Access Compliance Report Public Rights-of-Way (Curb Ramps)

Main Street: SILVER_FOX_RD		Cross Street: TIGERTAIL_DR		Location:	SW
ADA ID: RPRK211206172601	Ramp Type: Type 4 - Parallel	Initial Pass/Fail: Fail	Overall Compliance: No	Severity Score:	15

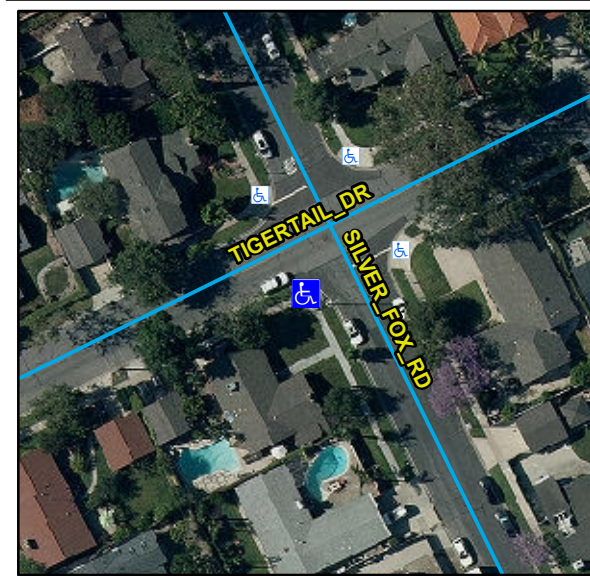
Remove & Replace Curb Ramp With Two New Directional Ramps or Equivalent.
